Byers Gill Solar Development

PINS Ref: EN010139

Landscape & Visual Review

Bishopton Villages Action Group

Study Area

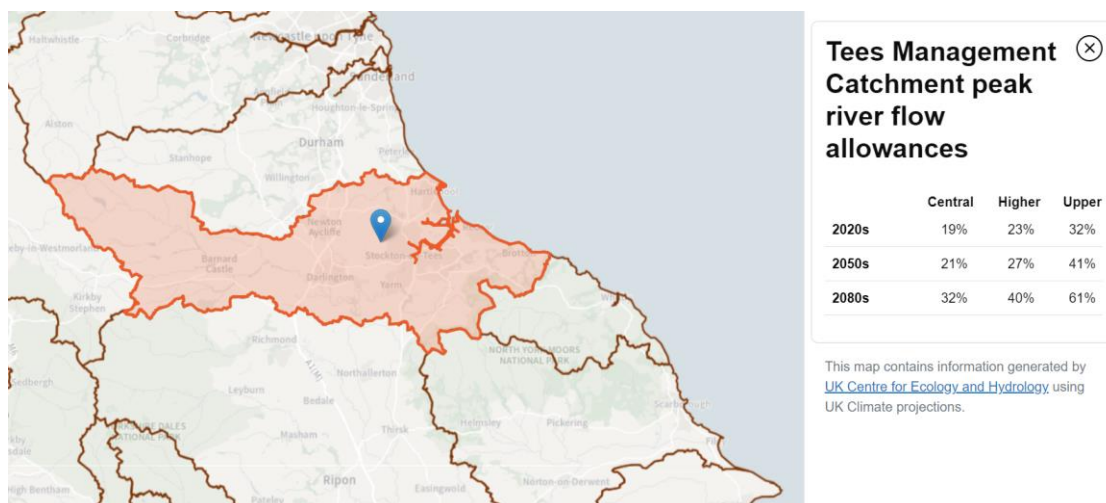
- 3.2.33 LVIA para. 7.6.1 explains that at the start of the LVIA process, the LVIA study area boundary was set at 2km from the panel areas. However, following responses to the scoping exercise, for the PEIR stage the boundary was increased to 5km. Following preliminary stakeholder consultation on the Application (see Principal Areas of Disagreement Statements (PADS) in ES Doc 7.6 *Potential Main Issues for Examination* (PMIE)), the boundary was set to 3km.

- 3.2.34 I **agree** that the 3km LVIA study area boundary is adequate, on the basis that no *significant* adverse landscape or visual effects are likely to arise beyond 3km from the panel areas.

- 3.2.35 But please note that in principle, I do not agree that it is appropriate to use the Zone of Theoretical Visibility (ZTV) plans to establish the study area boundary for assessing effects on landscape character (which includes for example experiential and recreational effects), because development will cause change to / give rise to effects on character, but it may not necessarily cause change to / give rise to effects on views (for example, the development may be able to be camouflaged, or fully-screened, or there may be no visual receptors within the development's zone of visual influence (ZVI)). In other words, as the popular saying goes, "*Just because you can't see something, doesn't mean it's not there*".

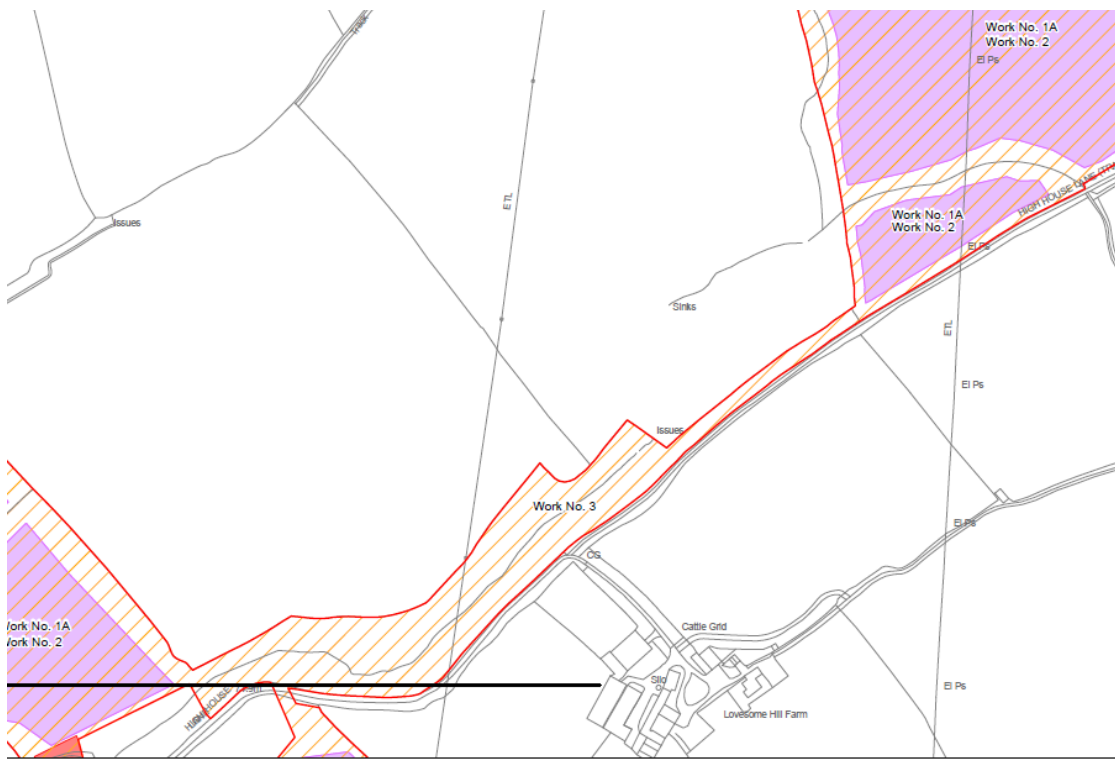
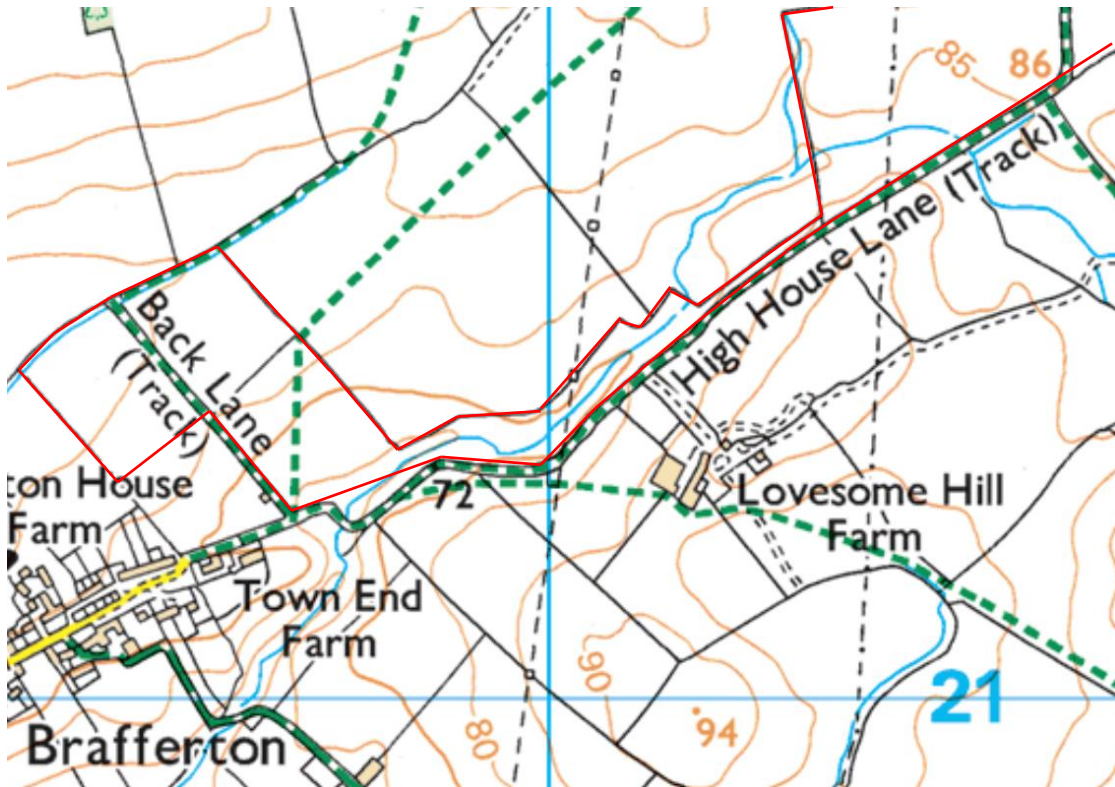
- 4.2.15 The relevant Works Plans (Drawing No. 2.2, Sheets 1 and 2 of 13) show that the access to the north-eastern section of Area A North would be taken from the south-eastern corner of the south-western section of Area A North (see extract from Works Plan Drawing No. 2.2 Sheet 3 of 13 below).

- 4.2.16 However, it is not clear to me how the access between the two parts of Area A North could be achieved without extensive engineering works and the removal of many mature hedges and trees.
- 4.2.17 The plans show that construction access between the south-western and north-eastern sections of Area A North would not be via the track: instead, it would follow the line of the track, on its

northern side, through a swathe of wooded pasture, c. 50m wide at the south-western end, and c. 6m wide (between mature hedges) at the north-eastern end, where the proposed access would enter the north-eastern section of Area A North.

Possible ridge-and-furrow / other medieval features around Brafferton (Environment Agency 2022)

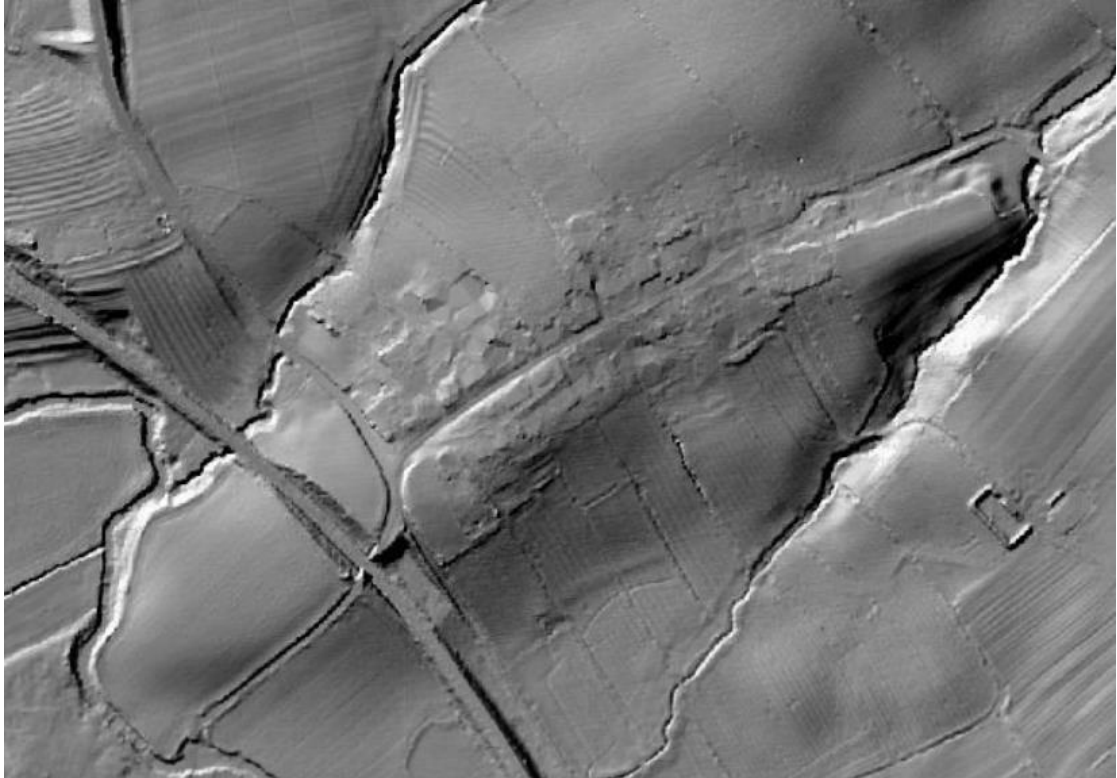
- 4.2.20 Whilst on site, I noticed what appeared to be medieval ridge-and-furrow in several fields around Brafferton, including adjacent to the western end of Area A North; later this was confirmed by LIDAR – see image overleaf. I also noticed what appear to be man-made landforms on the south side of High House Lane, at the eastern end of the village, which are also visible on the LIDAR extract (top right), and in the photo below the extract.

- 4.2.21 Also, para. 8.7.21 of ES Chapter 8 Cultural Heritage and Archaeology states that '*Analysis of LIDAR data and aerial photography have revealed evidence for approximately 28 deserted medieval settlements (DMV) throughout the study area, and immediately beyond... The outskirts of these medieval settlements, and the rural areas surrounding them, are characterised by ridge and furrow earthworks and field systems, suggesting a dominant agricultural presence in this area during the medieval period*', and para. 8.10.5 states that there are '*8.10.5. Large areas of post-medieval ridge and furrow throughout the Order Limits... The Proposed Development would remove or disturb archaeological remains associated with the asset*'.
